**IN THE MATTER** of Proposed Plan Change 7 to the Selwyn  
District Plan

**Report on Submissions relating to Proposed  
Plan Change 7**

**Growth of Townships, Urban Development and Rezoning of Land for  
Urban Purposes including the introduction of a new Living Z Zone at  
Lincoln and Rolleston**

<b>Report Number:</b>	<b>PC 080007</b>
<b>To:</b>	<b>Hearing Commissioners</b>
<b>From:</b>	<b>Cameron Wood</b>
<b>Hearing Dates:</b>	<b>3 May 2011</b>

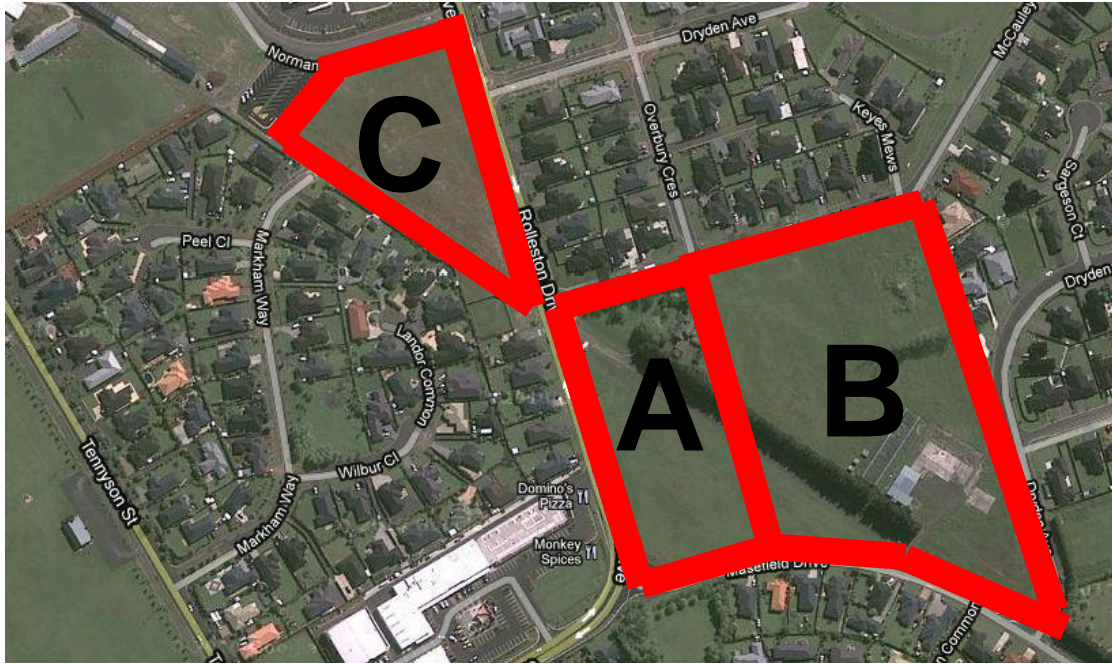
- 8.91 Submission 54 seeks that the introduction of increased residential activity has the potential to create adverse reverse sensitivity effects to existing commercial activities and existing commercial zones including the land at Masefield Mall and currently owned by Masefield Mall Ltd in Rolleston. The Submitter seeks that there should be additional Issues, Objectives, Policies, Rules and assessment criteria to address these effects.

- 8.92 Below is a map showing three key areas that will assist in assessing whether or not there is a reverse sensitivity issues for this submitter.
- 8.93 On the map:

#### Recommendation No 30

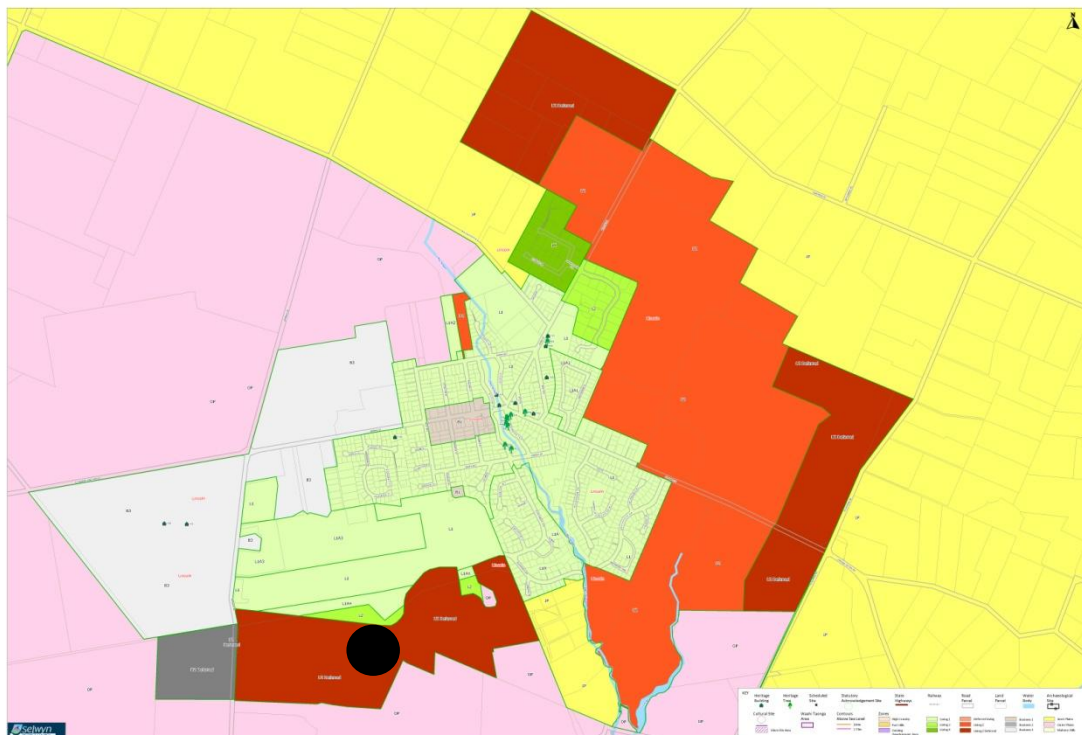
- The amended ODP now contains a separate layer diagram explaining how the movement network will work. The layer clearly states primary and secondary roads will provide footpaths and safe cycle routes. Tertiary roads will also provide adequate space for cyclists and convenient pedestrian movements. Shared off-road pedestrian and cycle connections will be provided to achieve safe, attractive active transports corridors and recreational amenity. With this also shown in the ODP diagram, I am now satisfied that the amended ODP now addresses this criteria in B4.3.58.

9.85 As no scope issues have been identified with the modifications made to this ODP, I consider that the changes made now fully address the ODP criteria in Policy B4.3.58 and Policy 8 of PC1.

9.86 Therefore I support this modified ODP for this area and recommend it should be rezoned to Living Z.

The recommendation is that the submission 91 (Decision 5 and 6) seeking to include an ODP within PC7 be accepted (subject to new ODP submitted as part of the pre hearing meetings) and rezoned ODP area 6 to Living Z (Decision D7 and D8) should be accepted

#### *Issue 6: Support for ODP Area 1 Location Plan, Road Network & Density Plan, Green Network Plan & Blue Network and Services Plan*

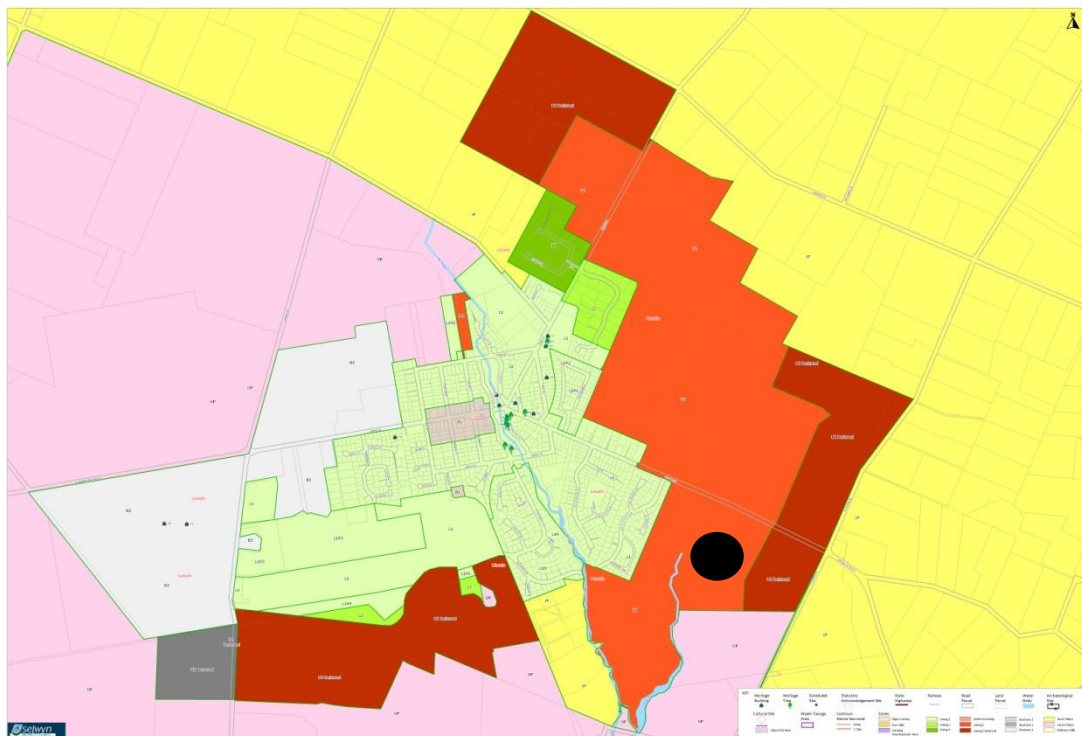
10.33 The submitter supports the extent and location of ODP Area 1, as shown on the ODP Location Plan, and the stormwater management network shown on ODP Area 1: Blue Network and Services Plan. Support is also expressed for the Road Network & Density Plan and Green Network Plan, subject to the amendments noted previously. Subject to the changes recommended in the preceding assessment, I recommend that these submissions therefore be accepted in part.

The recommendation is that submission S85 (Decision No's D22, D24, D26 & D27) seeking the retention of ODP Area 1: Blue Network and Services Plan be accepted in part.
